VTA's BART Silicon Valley Phase II Extension Project

CEQA Addendum to the
2018 Final Subsequent
Environmental Impact Report

Updated/Revised June 2024

Figure 10: 2024 Santa Clara Station Conceptual Site Plan
 VTA's BART Silicon Valley Phase II Extension Project

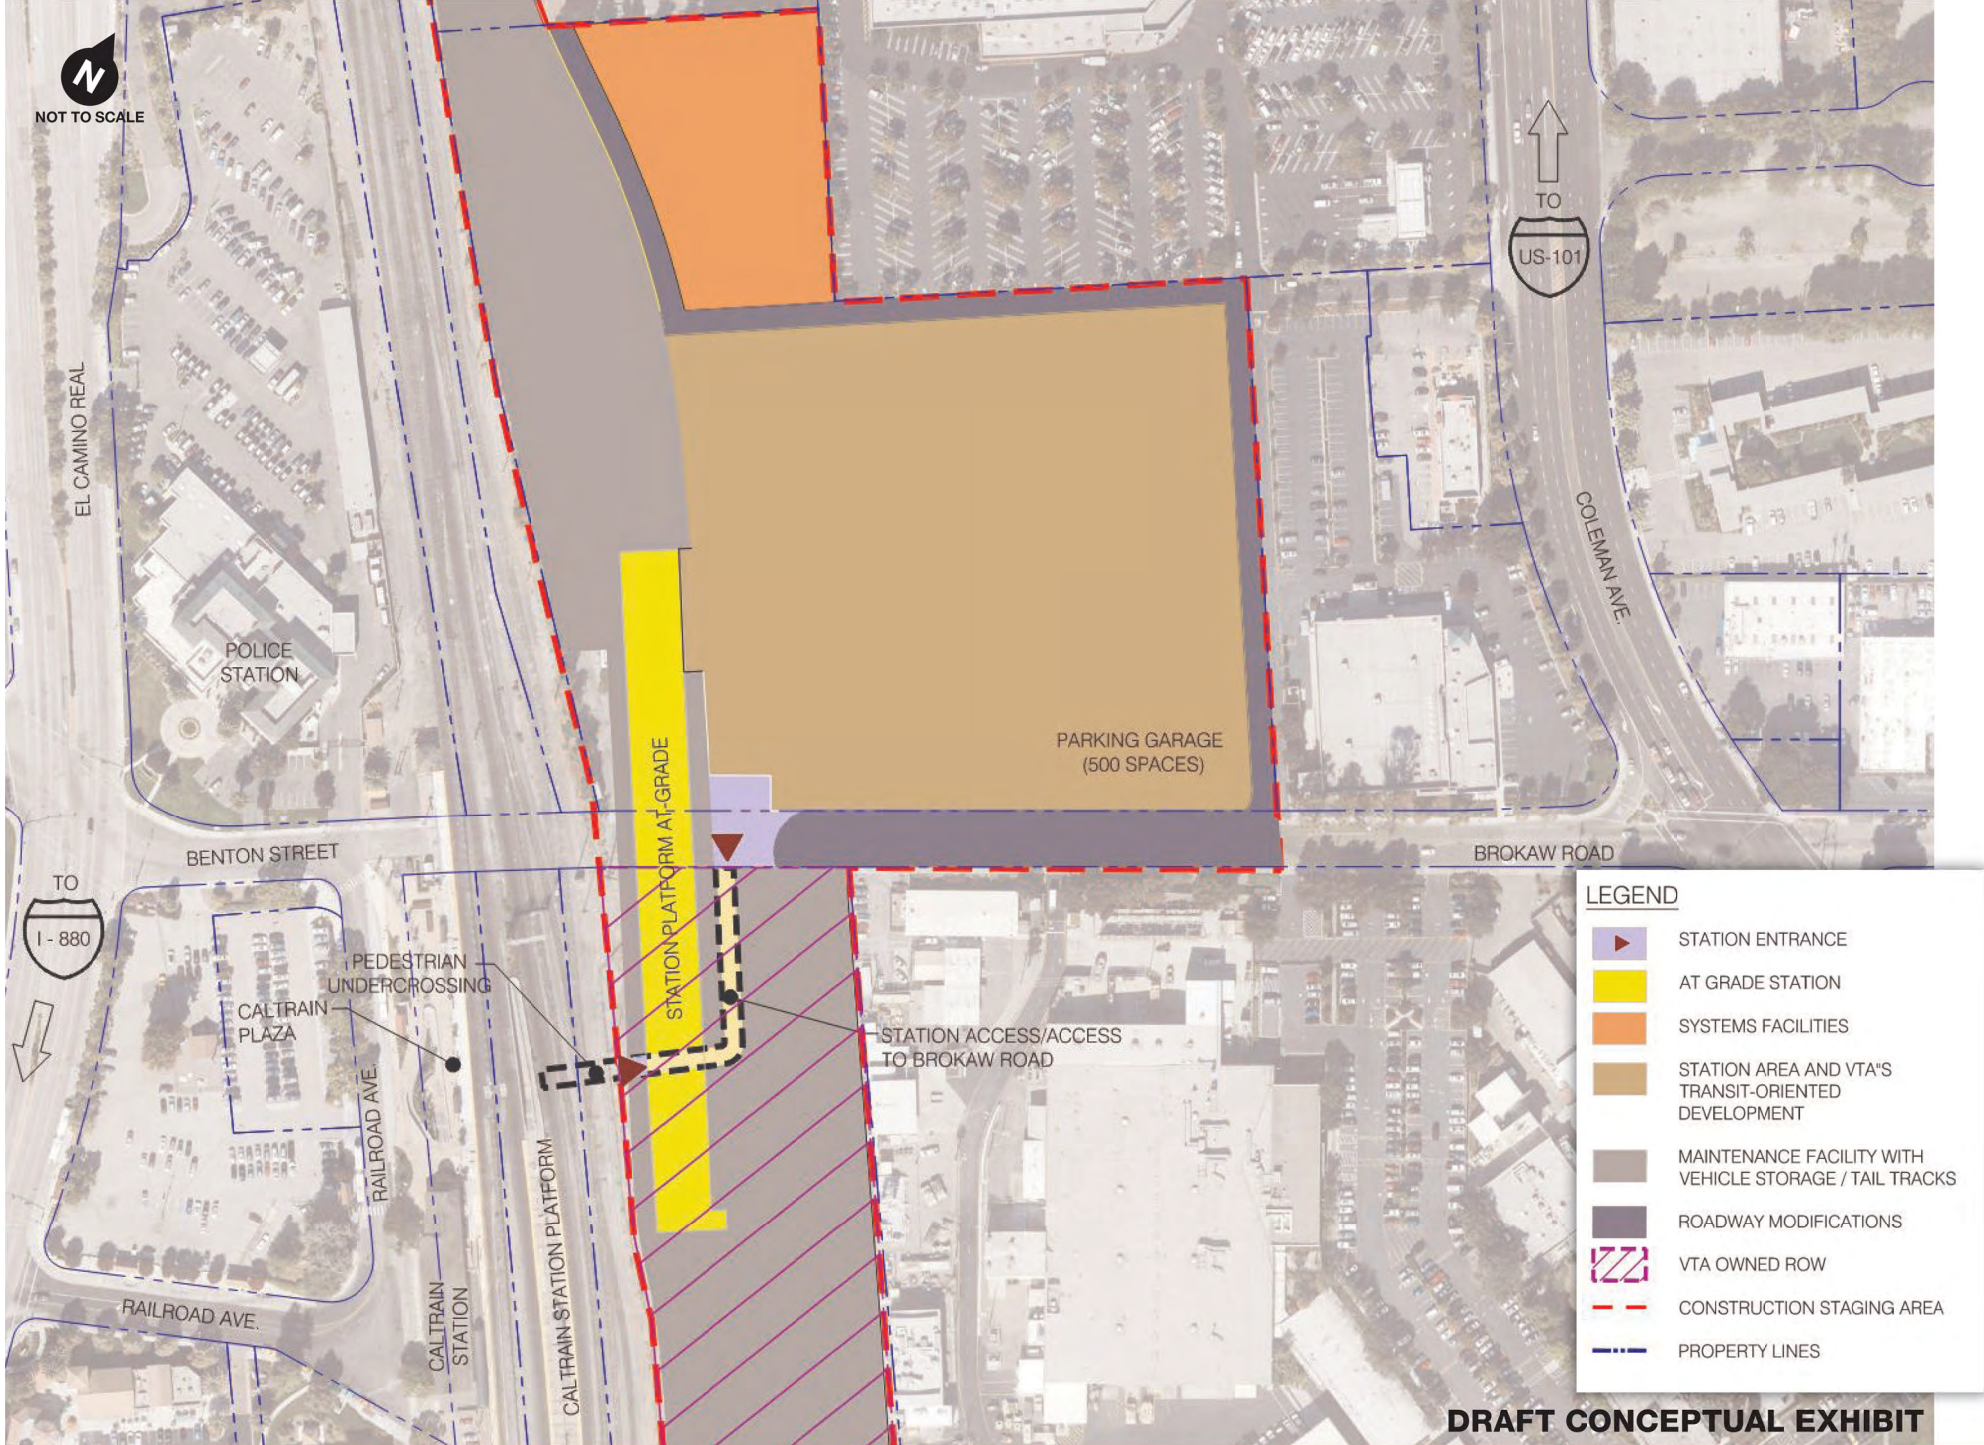
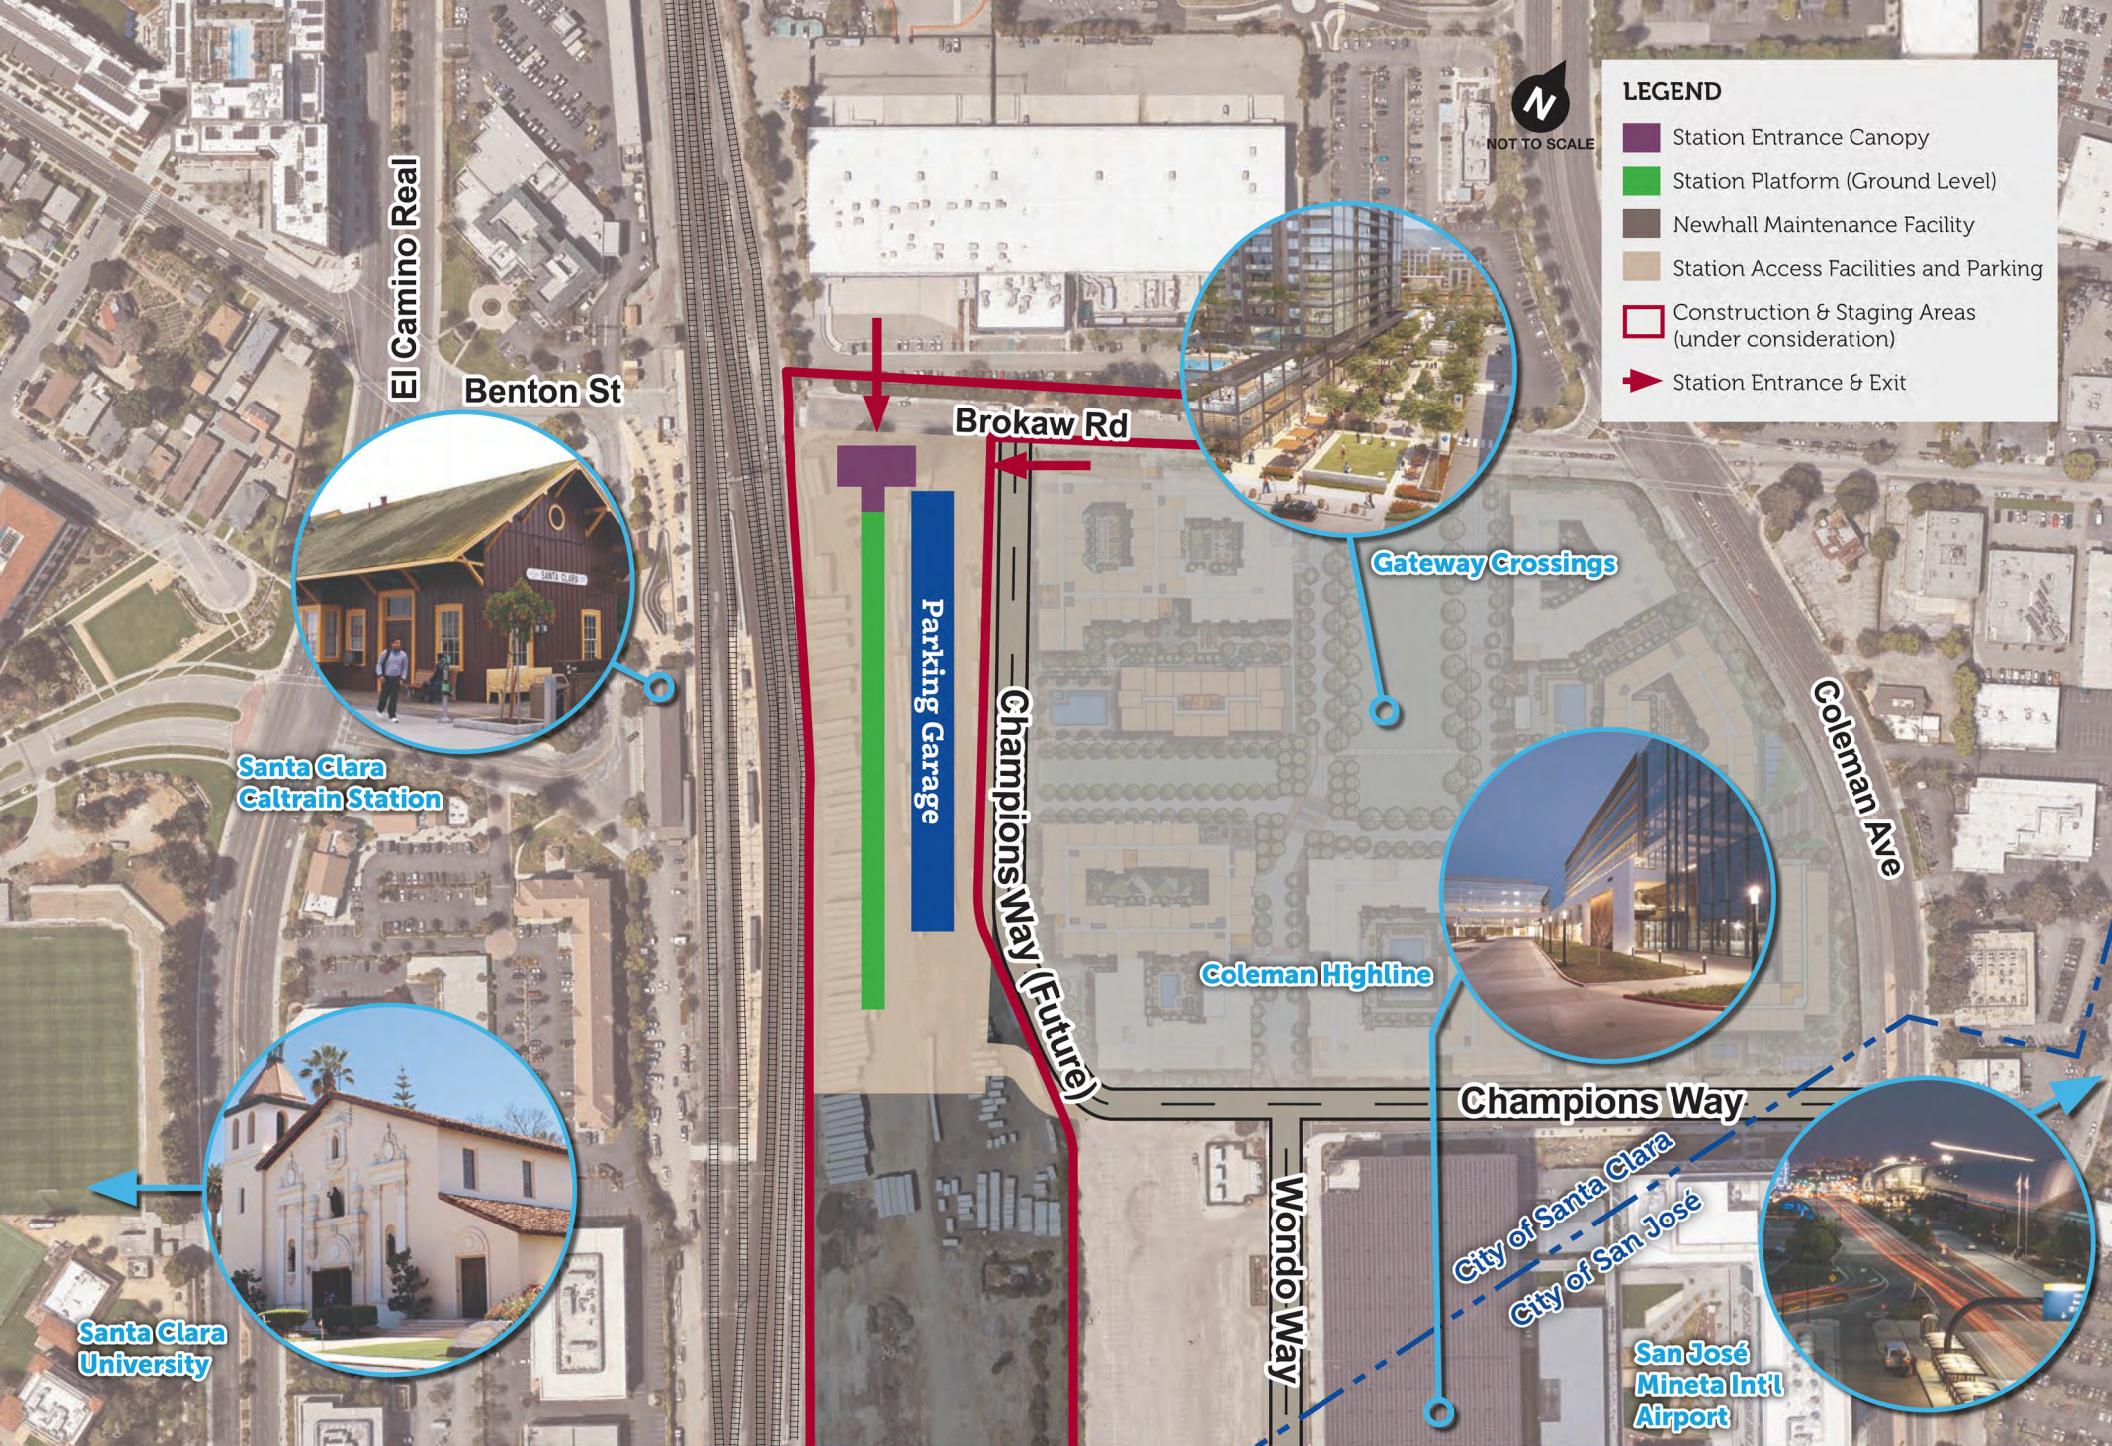
- **Santa Clara Station.** The design refinements for this station would result in a smaller station footprint compared to the design in the Final SEIS/SEIR, as an approximately 12-acre private property north of Brokaw Road in the City of Santa Clara is no longer needed for the Santa Clara Station. All station facilities formerly located north of Brokaw Road would be shifted south of Brokaw Road and within a VTA-owned property that includes the Newhall Maintenance Facility. Figures 9 and 10 show the previous and updated designs.

- **Santa Clara Station.** The Santa Clara Station footprint has been shifted south of Brokaw Road and incorporated into the 40-acre VTA-owned property that will contain the Newhall Maintenance Facility, which has been slightly reconfigured to provide space for the station. An approximately 12-acre private property north of Brokaw Road in the City of Santa Clara is no longer needed for Santa Clara Station and has been removed from the project footprint.

Figure 1 Comparison of 2018 Design (left) and Design Refinements (right)

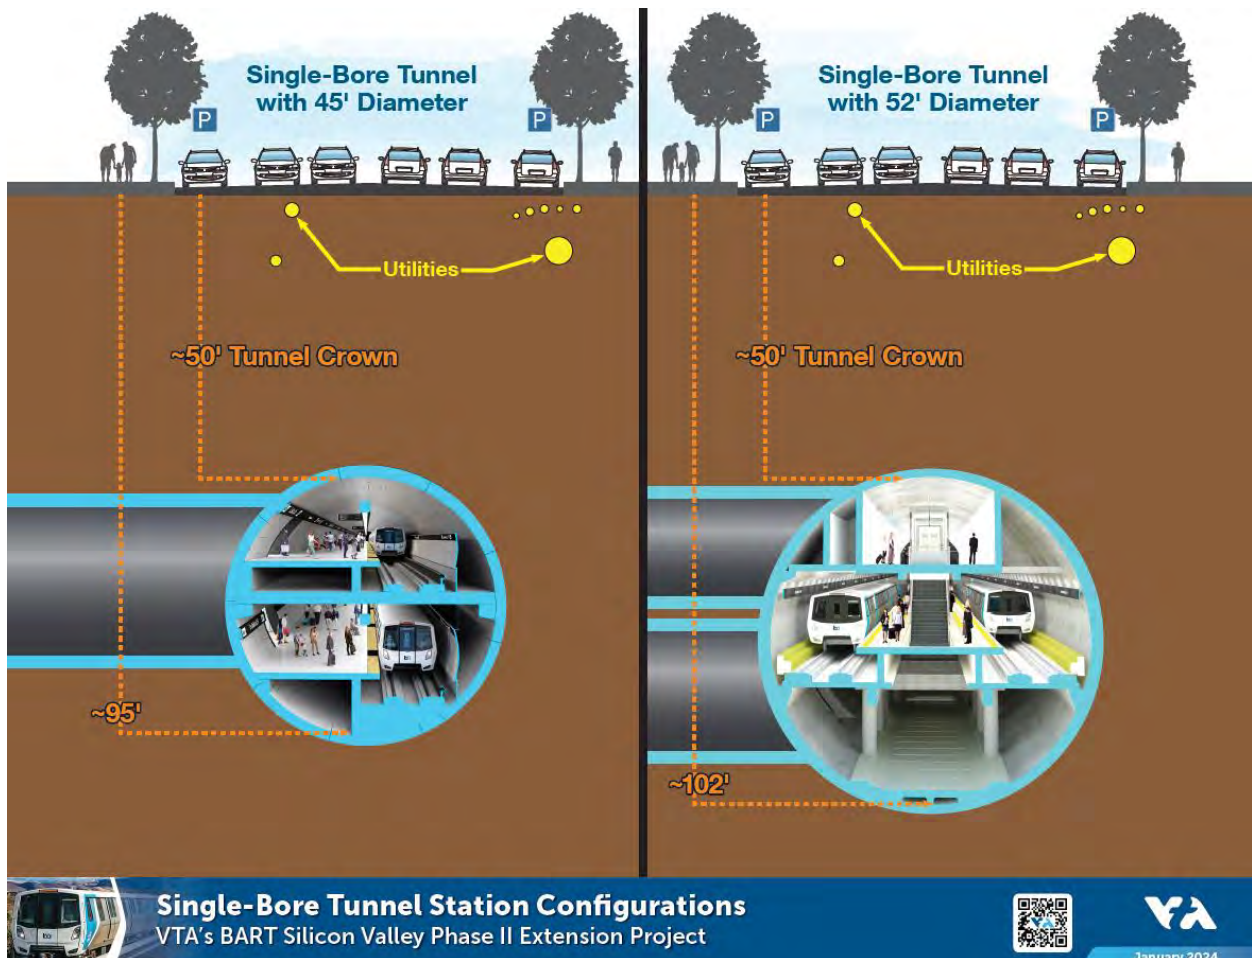
- **Tunnel Configuration and Alignment.** Two tunnel configuration options (twin-bore and single-bore) were considered in the Final SEIS/SEIR, and the Single-Bore Option was selected in the ROD. The single-bore alignment configuration approved in the ROD included both a stacked and a side-by-side configuration, with transition zones in between. Since the ROD was issued in 2018, the single-bore configuration was further refined. The entire alignment would now be in a side-by-side configuration and no longer in a stacked configuration (see figure below). To maintain minimum platform widths at the three underground stations, the tunnel's inner and outer diameters would be increased from approximately 41 feet to 48 feet and 45 feet to 52 feet, respectively. In addition, there have been vertical alignment shifts (up to approximately 13 feet shallower and up to approximately 33 feet deeper) and horizontal alignment shifts (up to 125 feet at the tunnel curve at the widest diversion point just west of

Diridon Station to accommodate the larger tunnel diameter, side-by-side track configuration, and maximum design speeds).
